Project	107 Felpham Way Bognor Regis, PO22 8QB
Drawing	Proposed Ground and First Floor Plans Typical Section A-A
Date	February 2021
Drawn by	KC
Scales	1:50@A1/1:100@A3
Suitability	Planning
Doc No	019-DLS-00-01-DR-A-1012
Revision	J

PROPOSED FIRST FLOOR PLAN

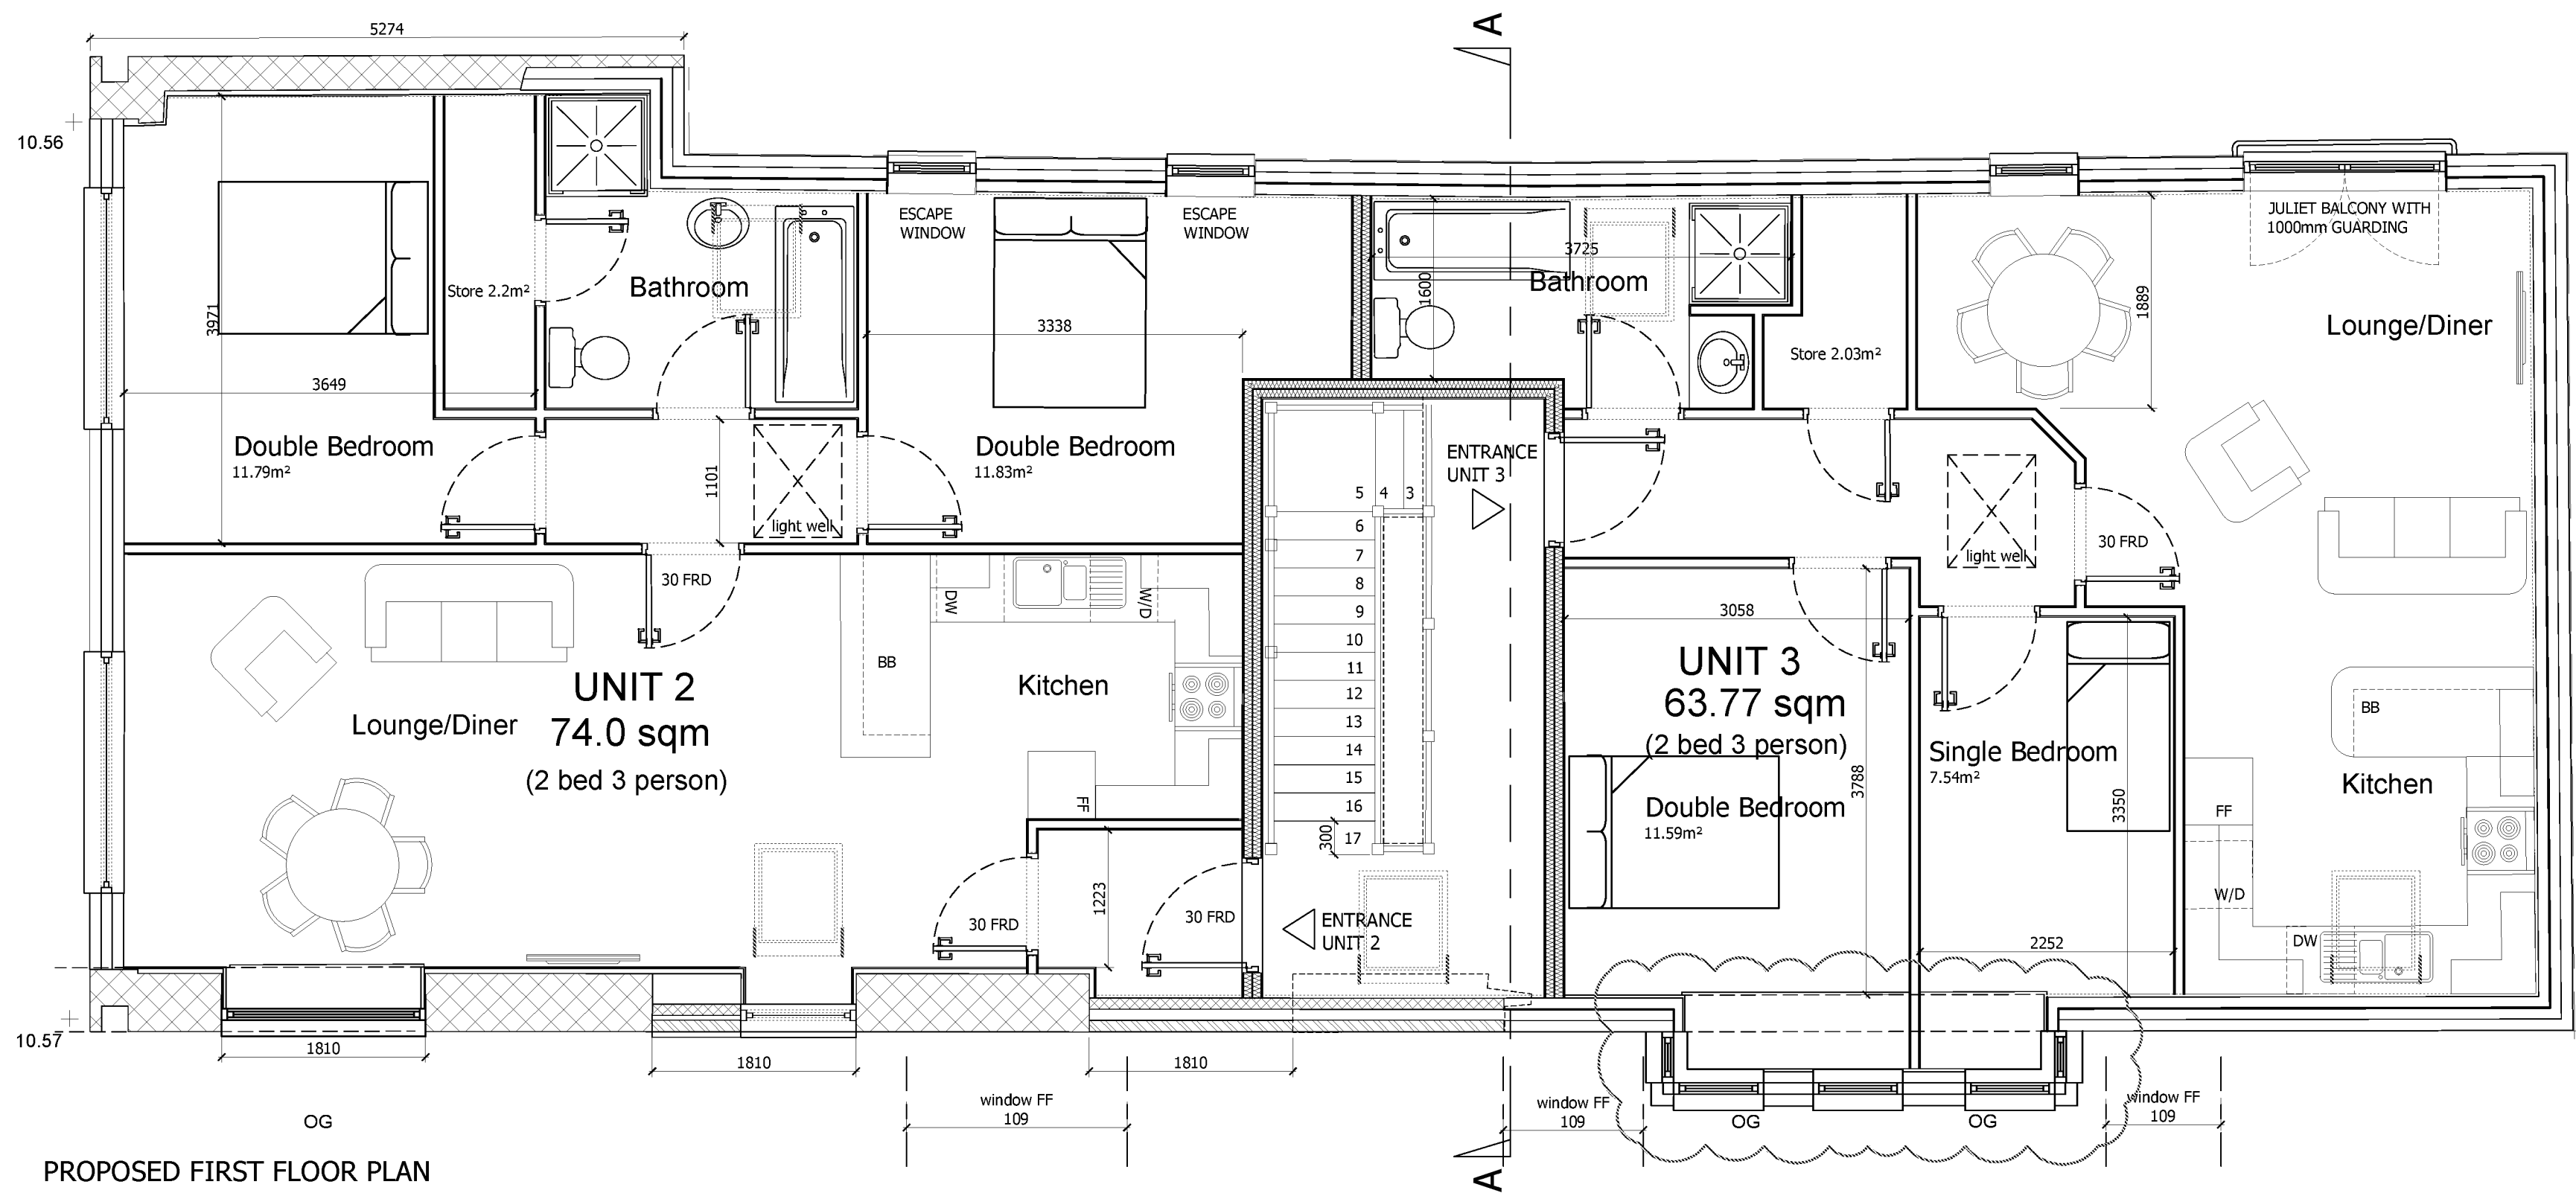
Unit 3 projecting bay windows to bedrooms reinstated

TYPICAL SECTION A-A

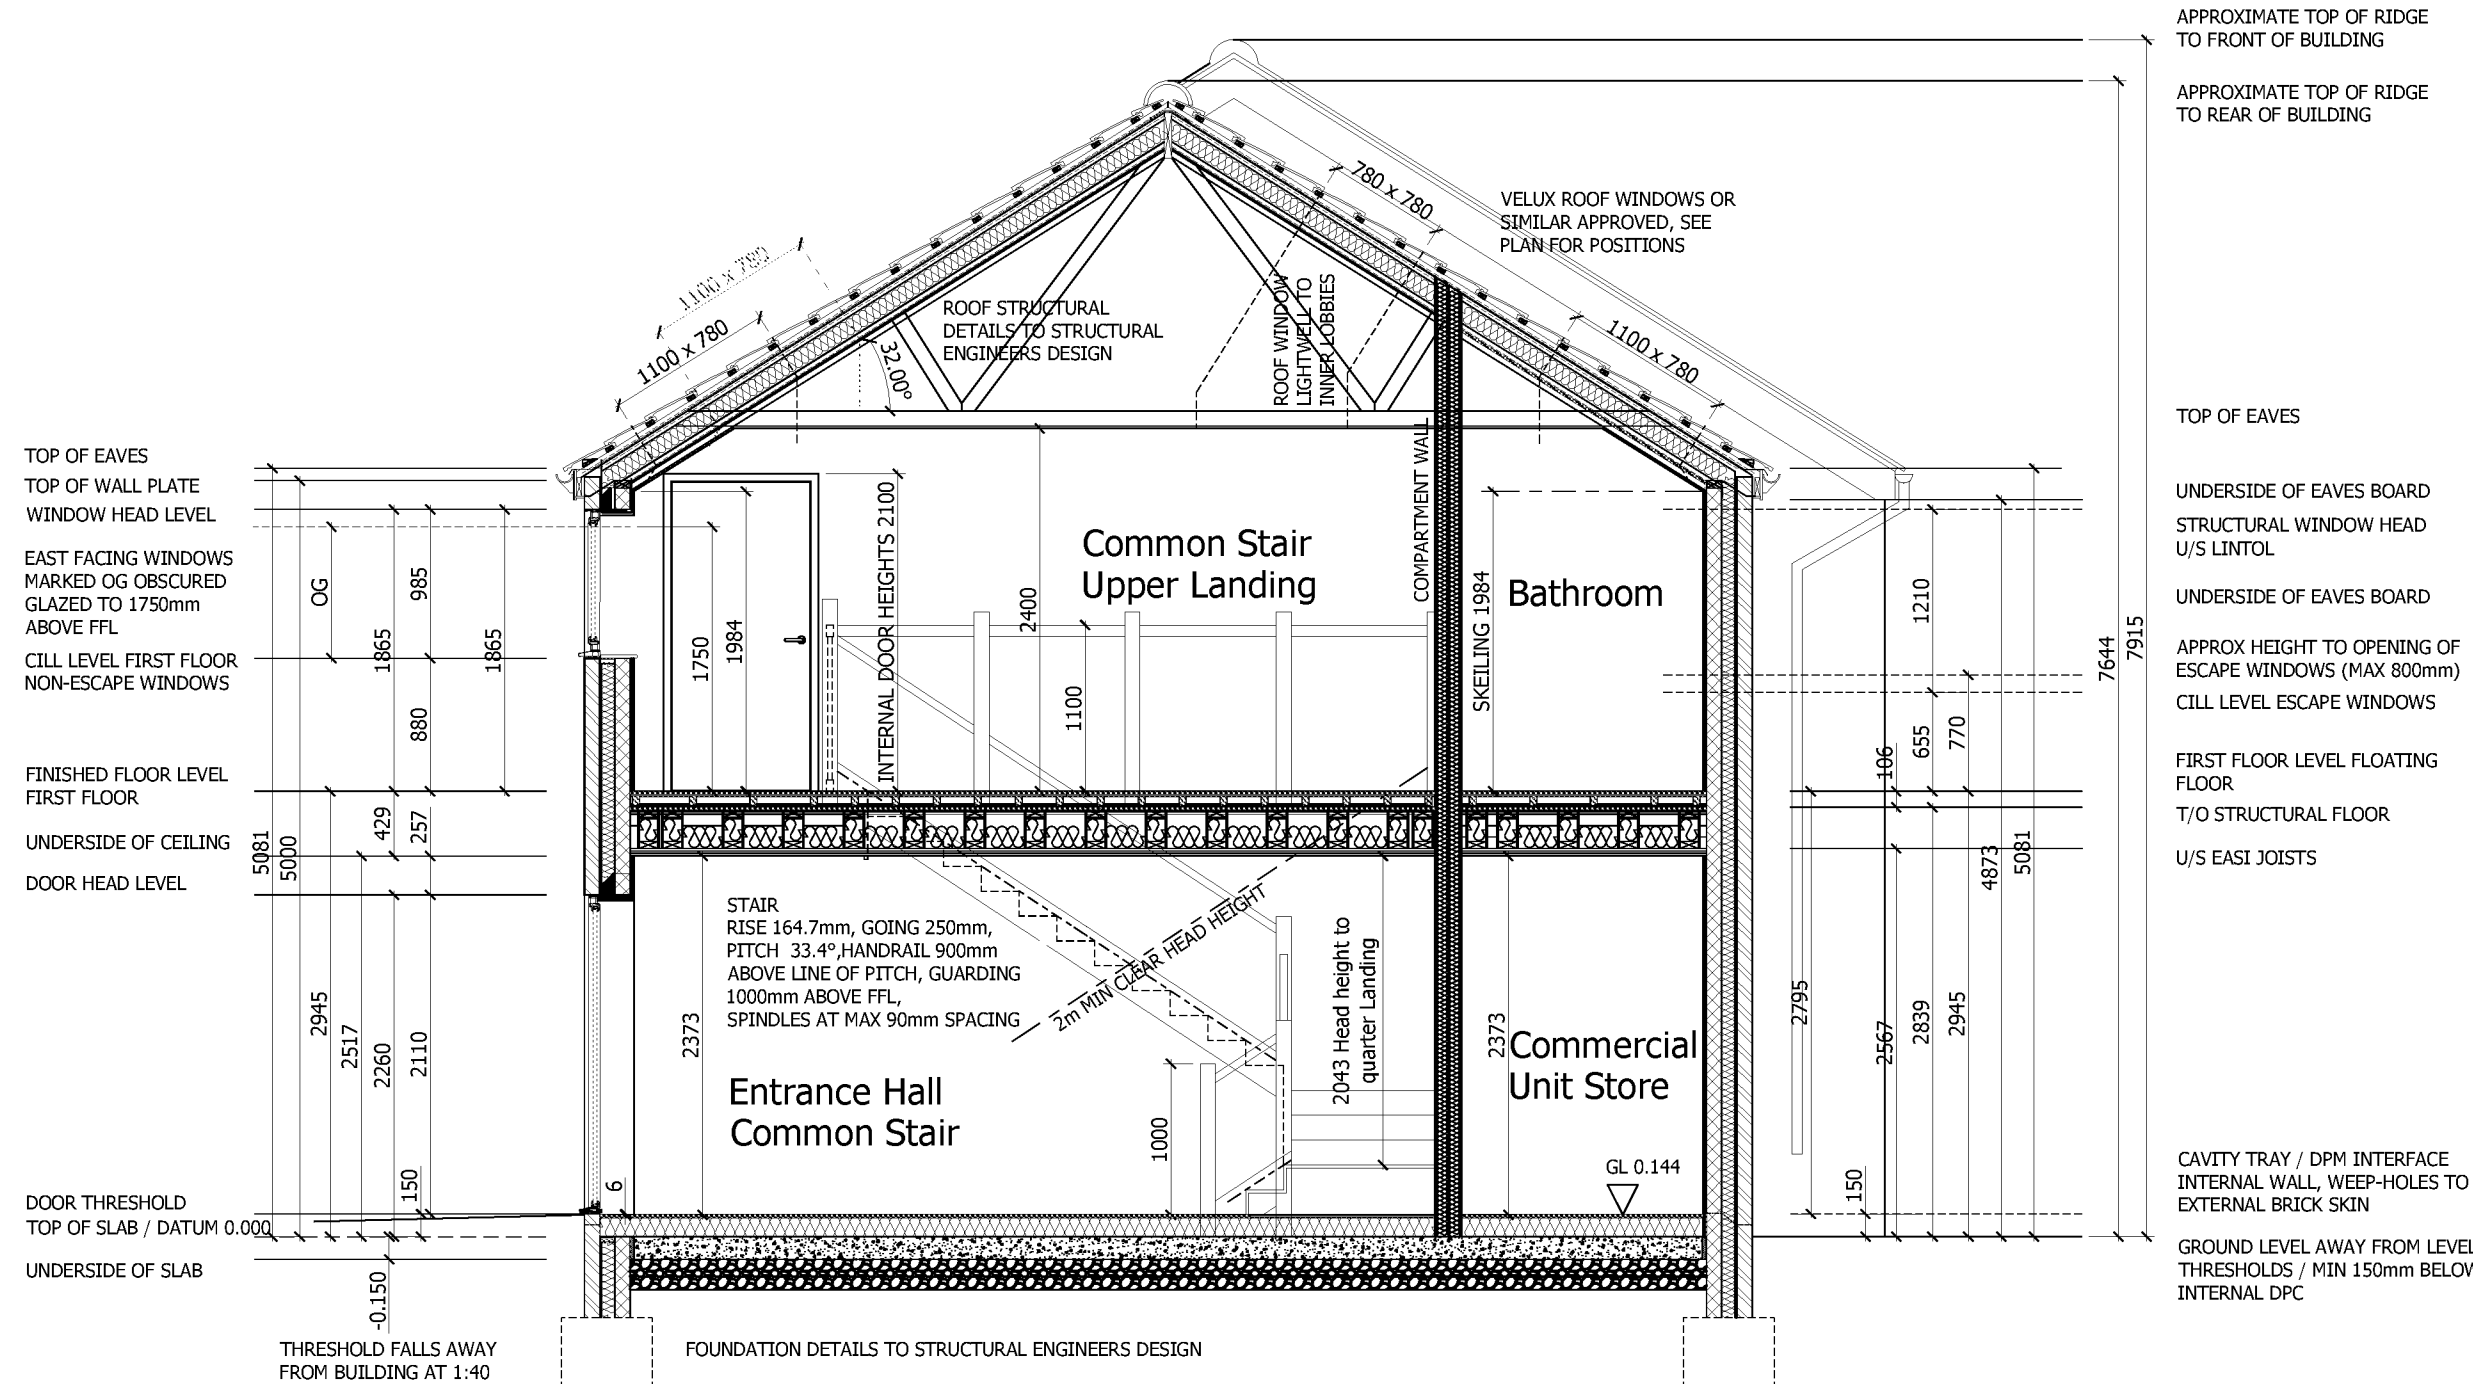
D	Disabled Use Wc moved to west side of commercial unit, escape door and windows moved along wall	KC	15.02.21
E	Store cupboard to commercial unit relocated and window added to existing double door opening in retained section of wall. Eaves height on section adjusted and flat roof section added to keep ridge height at level on approved Planning drawings	KC	16.02.21
F	Roof changed on section to a mono-pitch roof, flat central section omitted.	KC	18.02.21
G	Windows changed on East elevation to avoid direct alignment with windows opposite to No. 109 Felpham Way. Juliet Balcony omitted on South elevation, triple window added.	KC	08.05.21
H	Projecting Bay windows removed, windows to building frontage at first floor level equalised, roof window to bathroom Unit 2 moved, section revised to show equal pitched roof to building frontage	KC	03.06.21
J	Window to Kitchen Unit 3, First Floor level omitted	KC	03.06.21

PROPOSED GROUND FLOOR PLAN

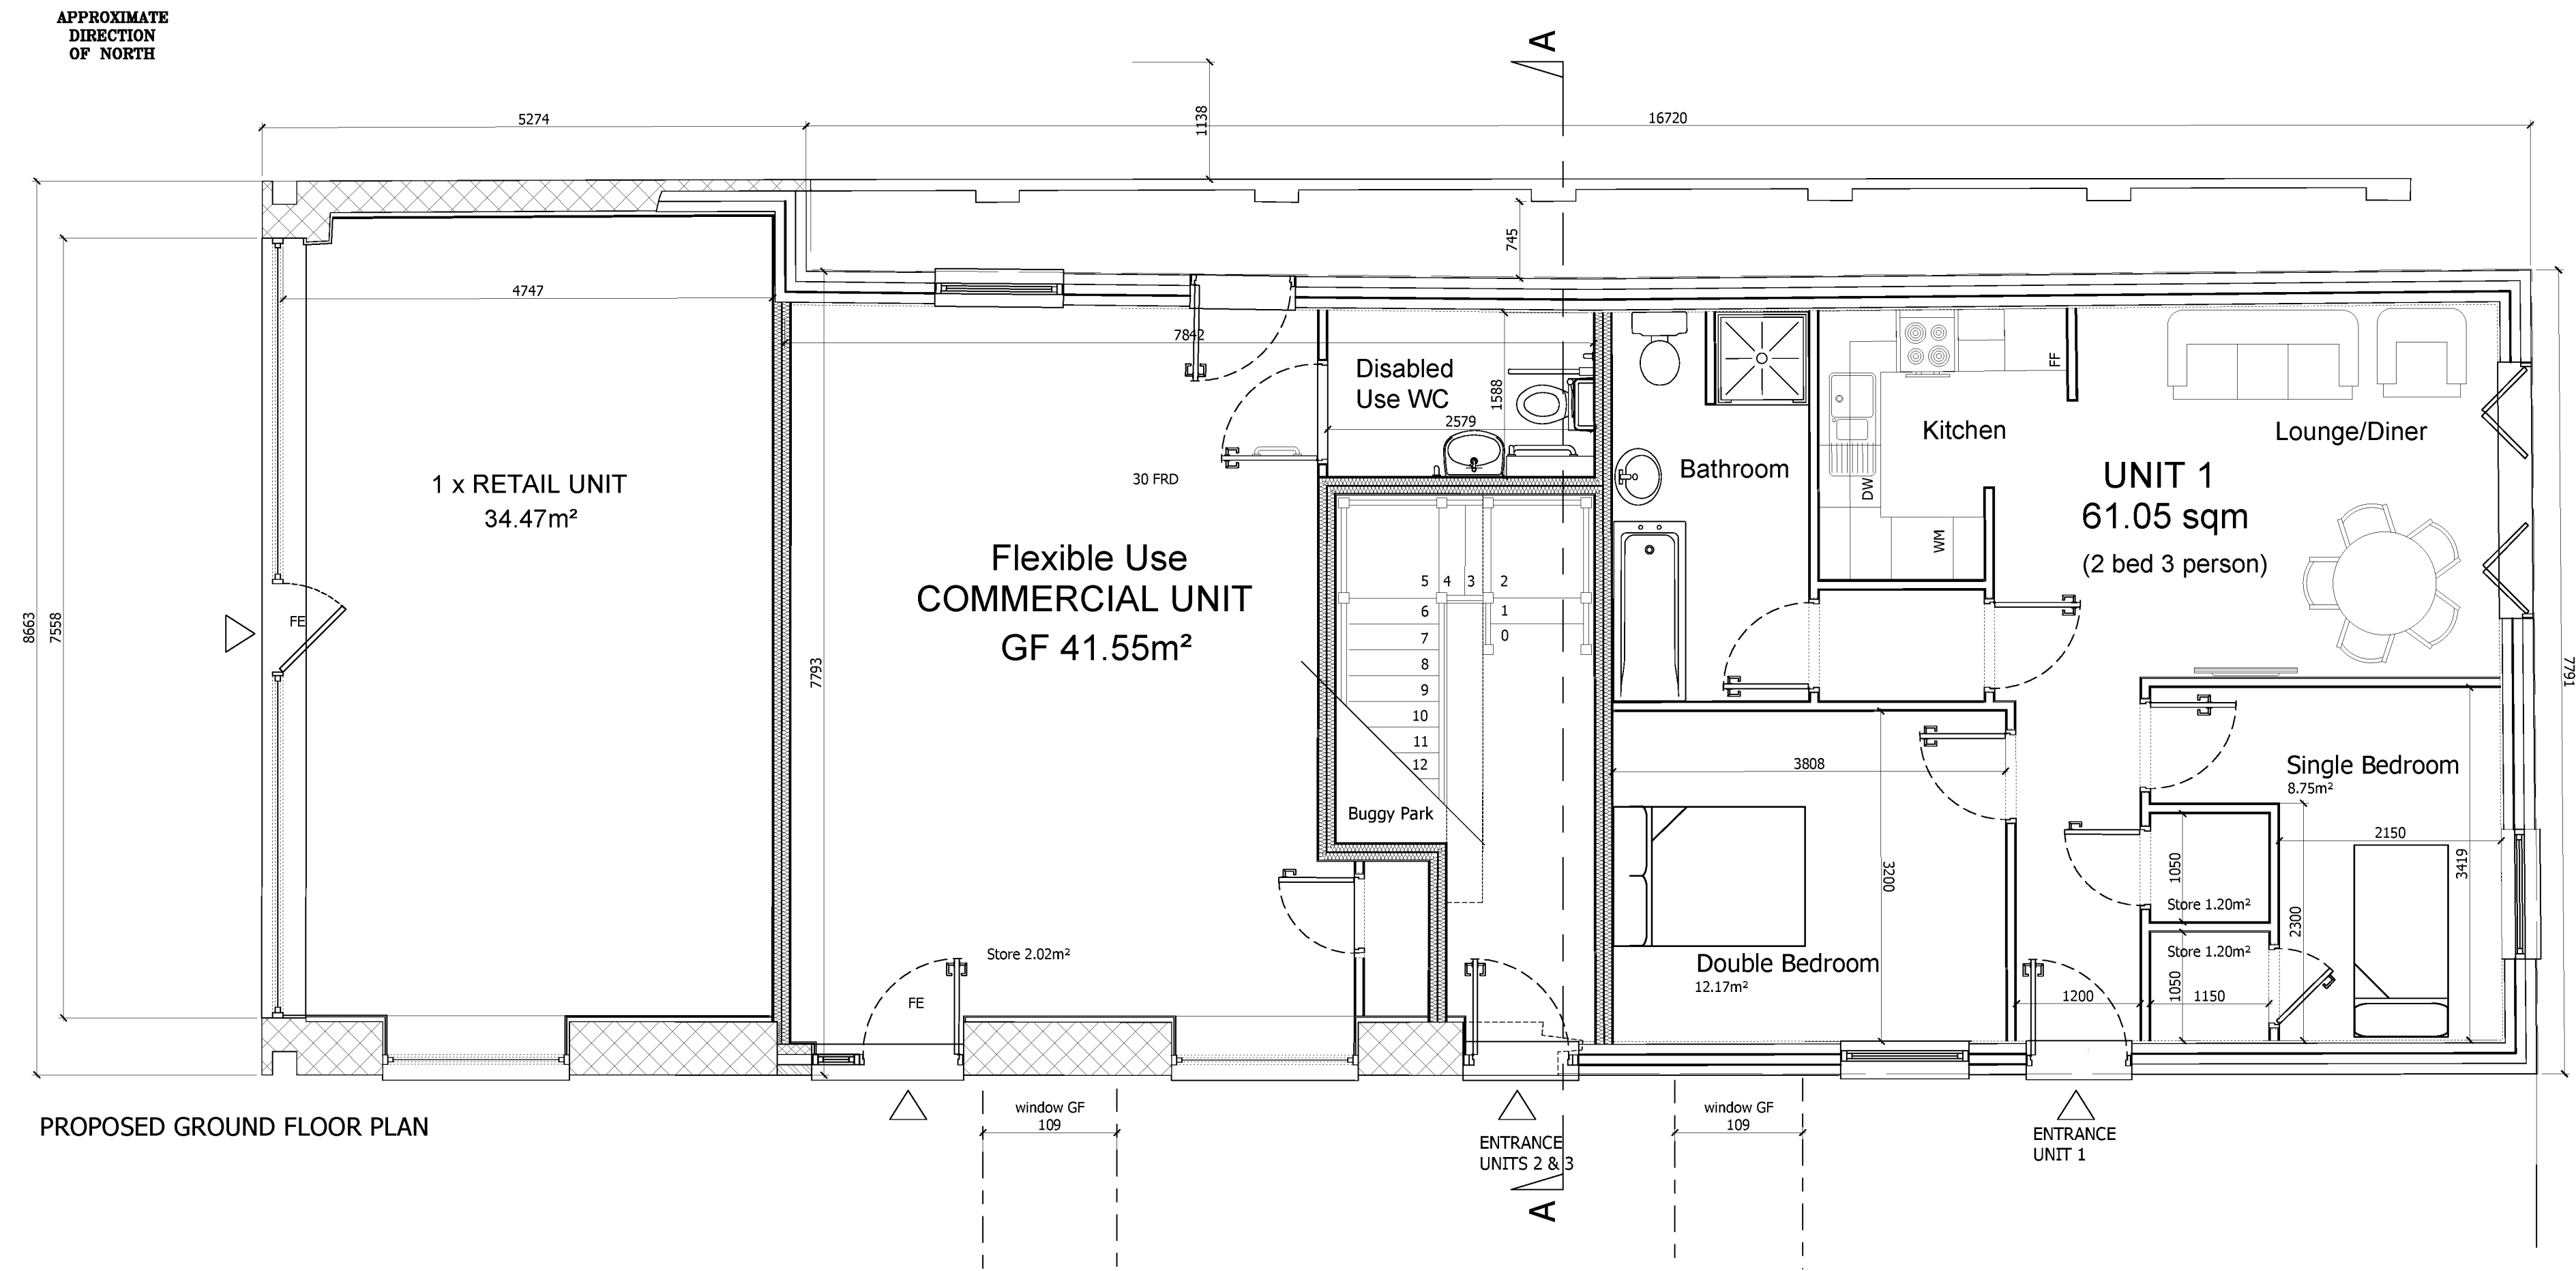
REV.	AMENDMENT	BY	DATE
A	Revision made to Ground Floor Flat to provide wardrobe to single bedroom and storage cupboard to the Hall. Bedroom sized to standards, increased space to Living / Dining Area.	KC	05.02.21
B	First Floor, shaded areas added to show how Flat 2 may be changed to provide a 2B / 4P Unit. Revision to Cupboard and Wardrobe between Hall and Single Bedroom, Area of Double Bedroom Increased. Single Bedroom increased in size due to width constraint, Living /Dining area decreased as a consequence.	KC	05.02.21
C	Store cupboard, windows and secondary escape door added to Commercial Unit. Flat 2 modified to 2B / 4P Unit. Flat 1 Modified to increase size of bedrooms, storage in hall split to provide wardrobe to Single Bedroom. Typical Section Added	KC	09.02.21
